LINCOLN PROFESSIONAL PARK FILING NO. 1 - LOT 2

UTILITY CONSTRUCTION DOCUMENTS

LINCOLN PROFESSIONAL PARK FILING NO. 1
LOT 2, PARKER, CO
7 BREW - PWSD CONSTRUCTION DOCUMENTS
COVERSHEET

C1.0

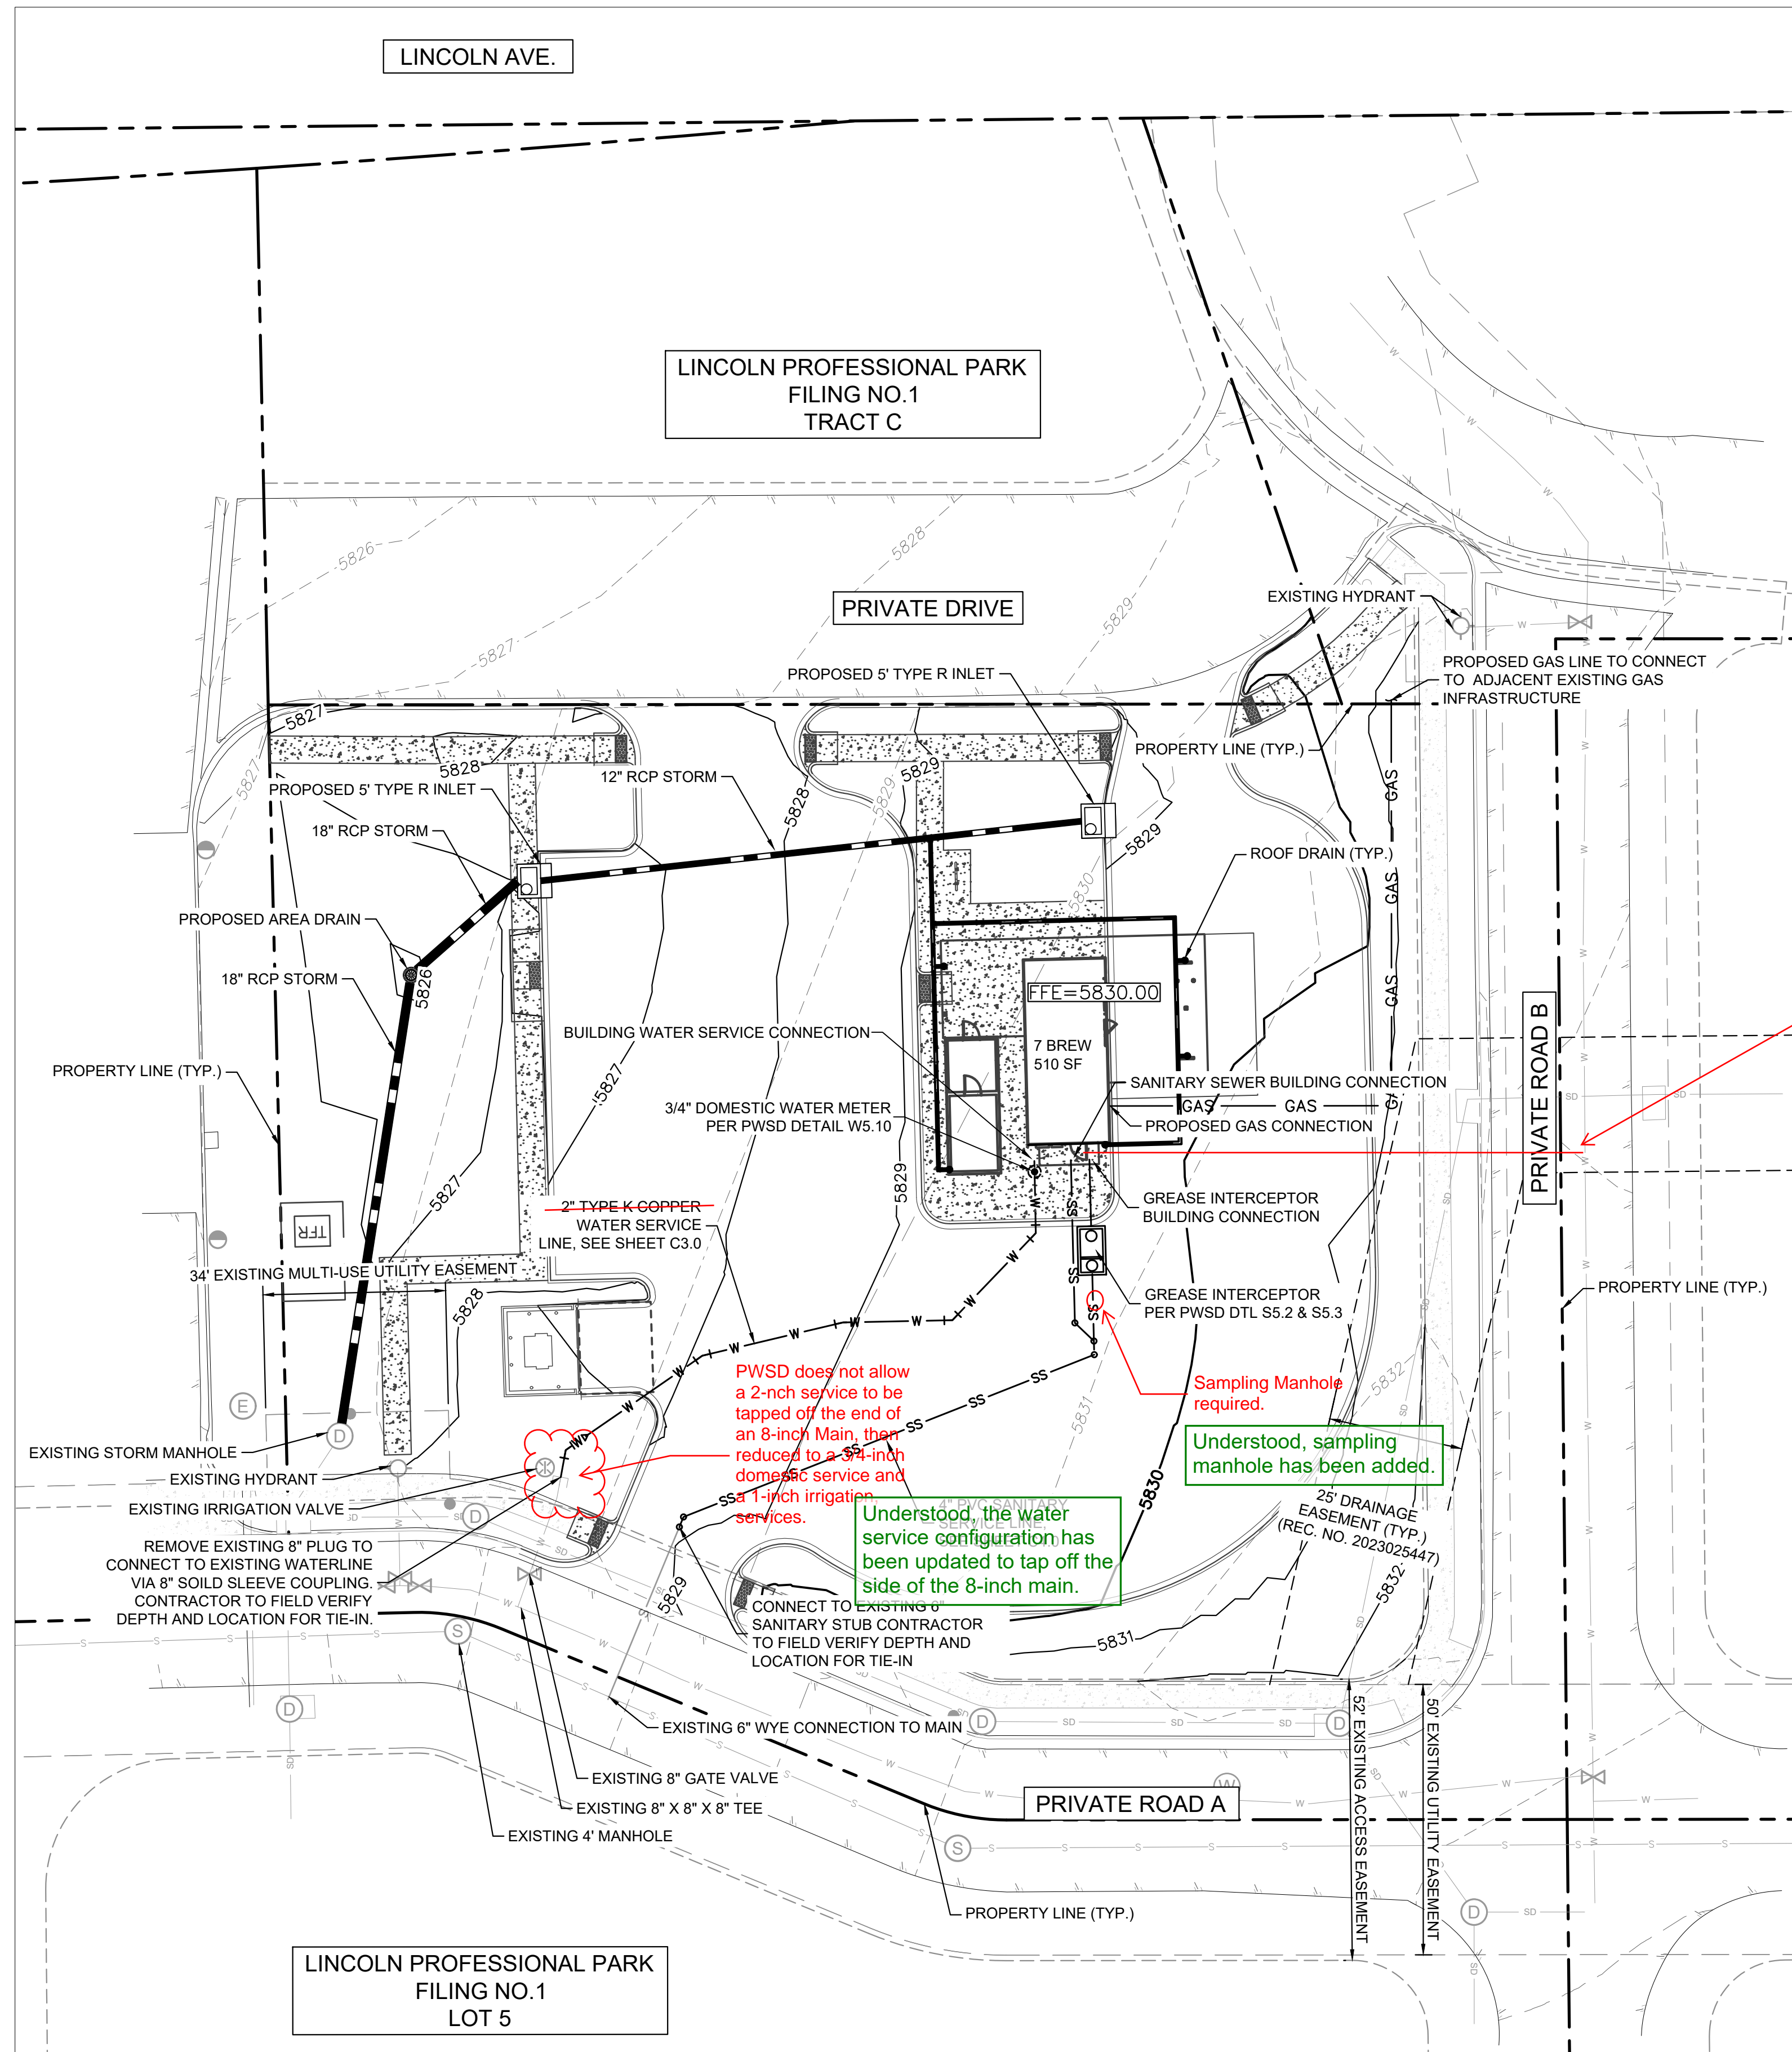
PWSD does not allow a 2-inch service to be tapped off the end of an 8-inch Main, then reduced to a 3/4-inch domestic service and a 1-inch irrigation services.

Understood, the water service configuration has been updated to tap off the side of the 8-inch main per discussions with the review team.

LINCOLN PROFESSIONAL PARK FILING NO. 1
 LOT 2, PARKER, CO
 7 BREW - CONSTRUCTION DOCUMENTS
 OVERALL UTILITY PLAN

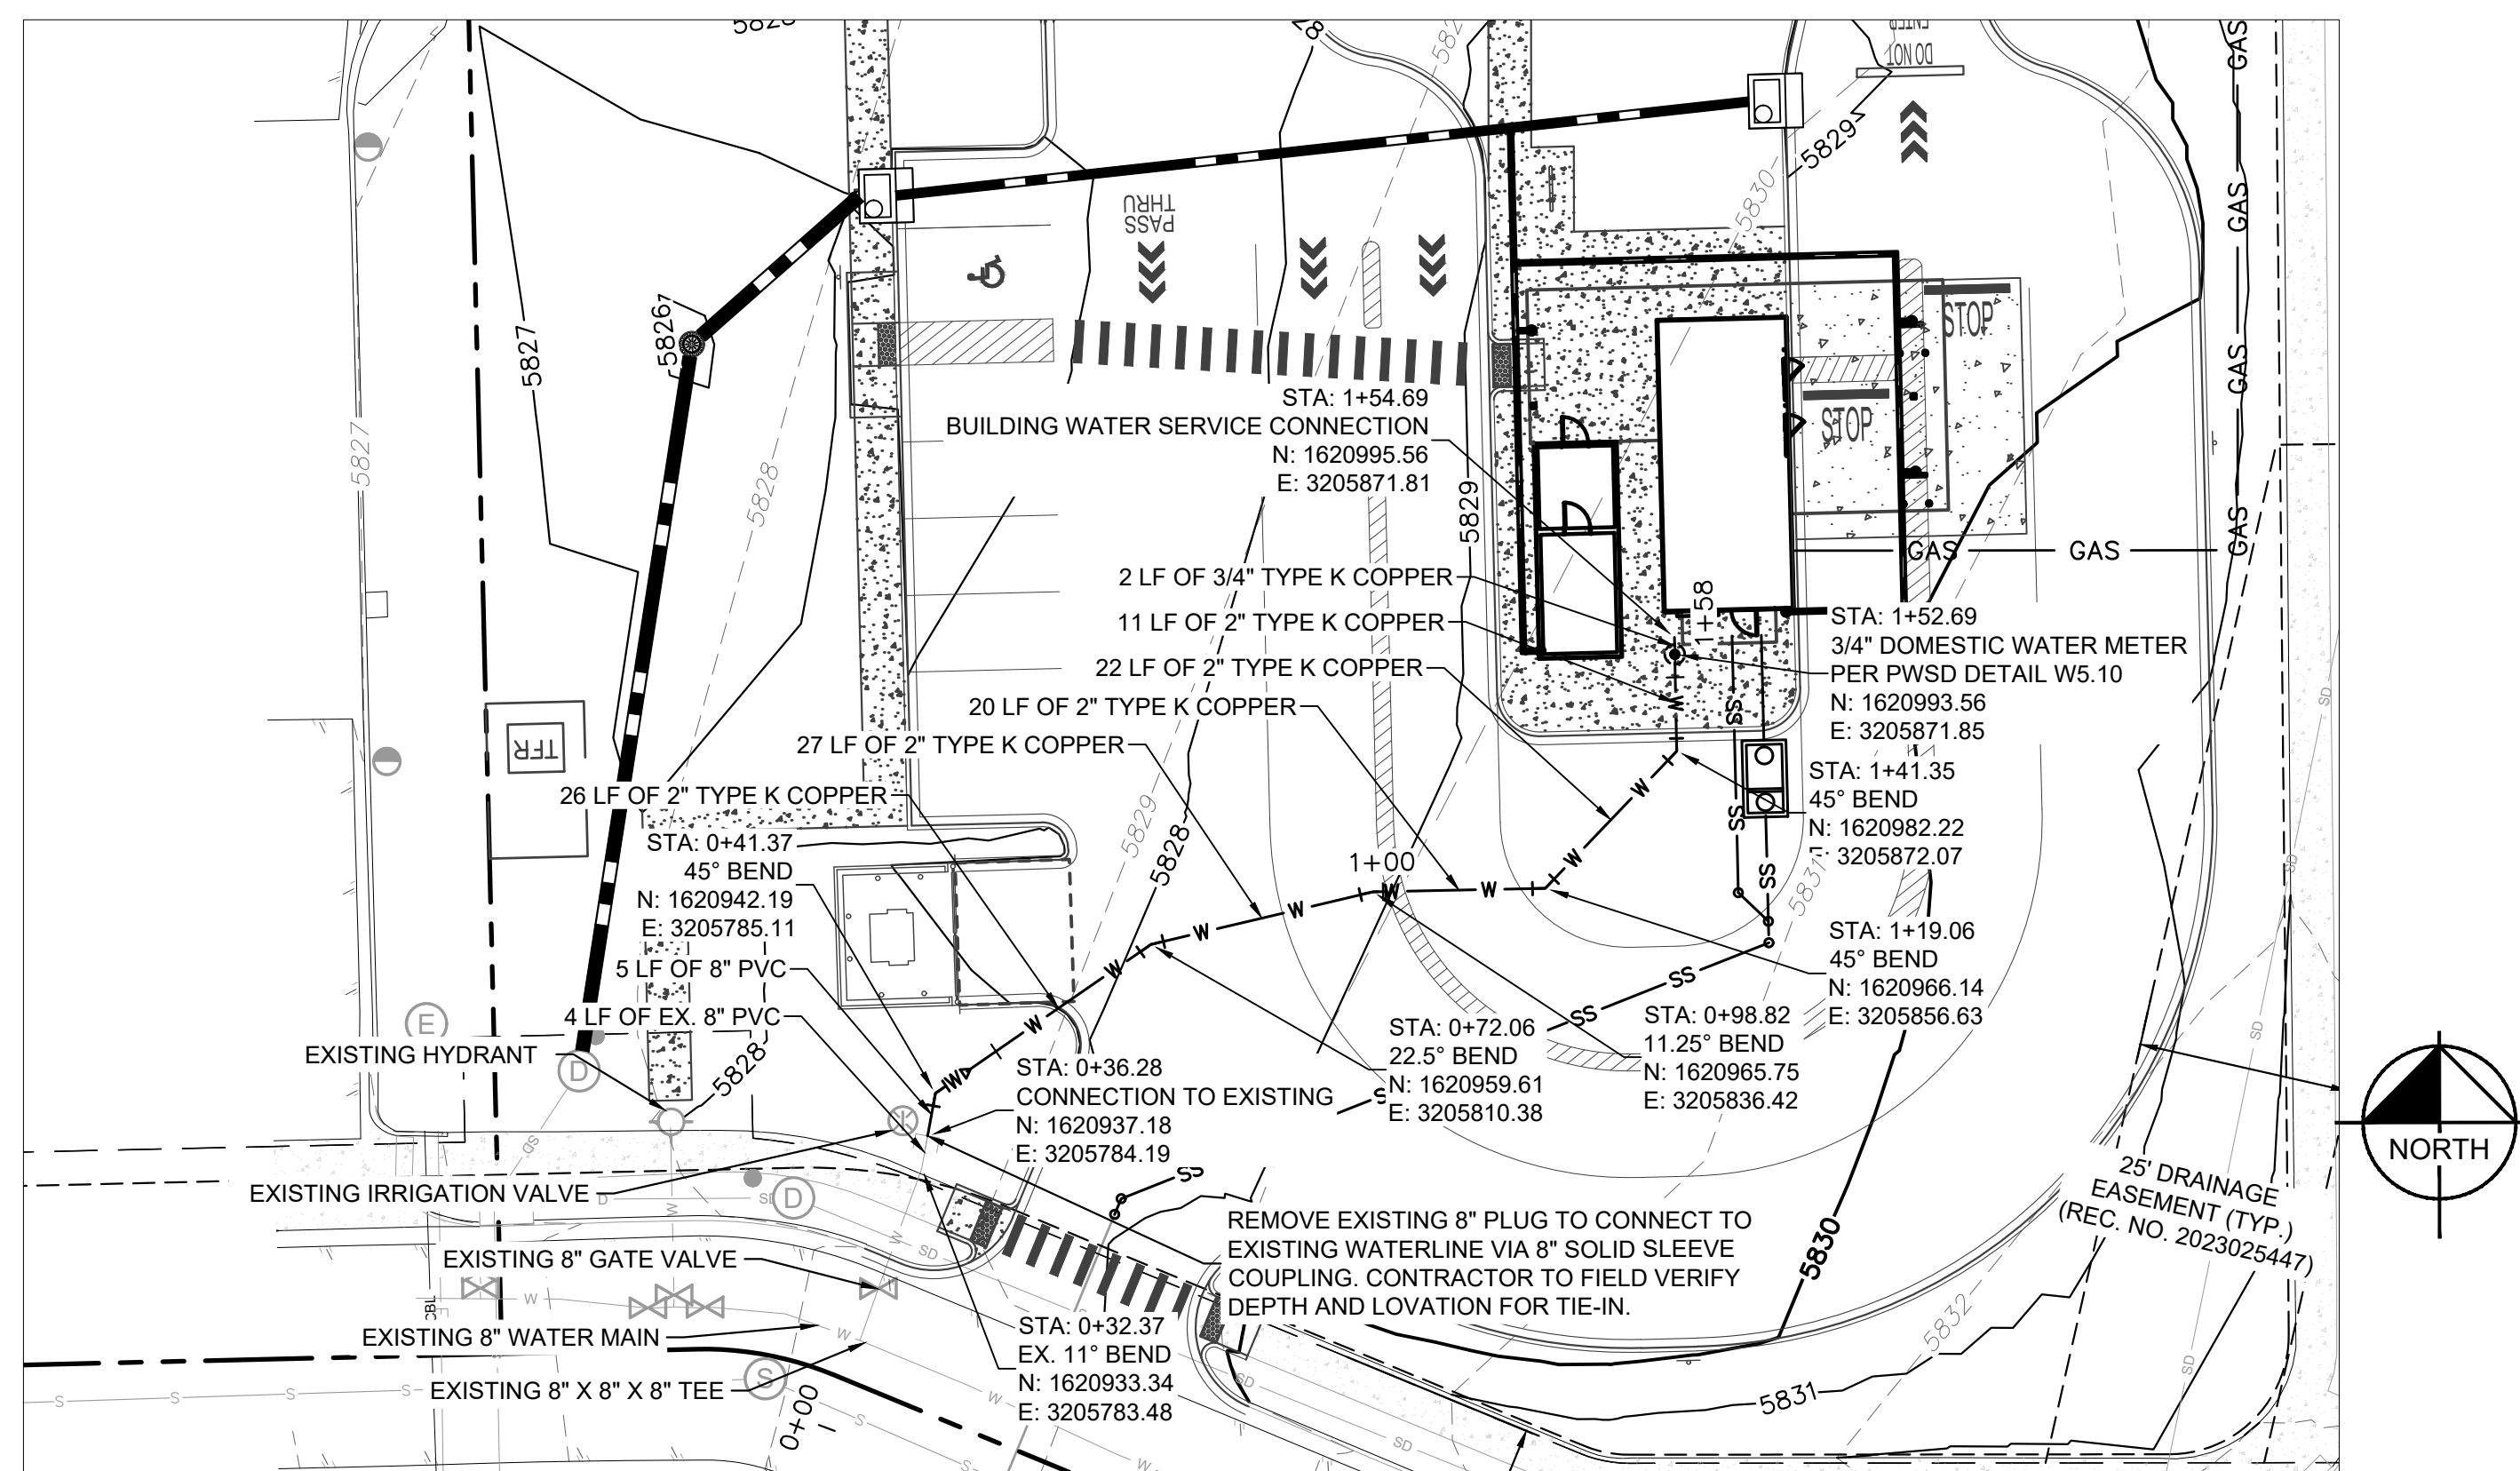
Alternative Water service.
Noted, thank you per discussions with Robert we will be tapping off the 8" main in the southwest
Domestic water service to be sized off plumbing fixture count, a Combo tap may be feasible for this project. Irrigation worksheet needed to confirm.
Understood, thank you.
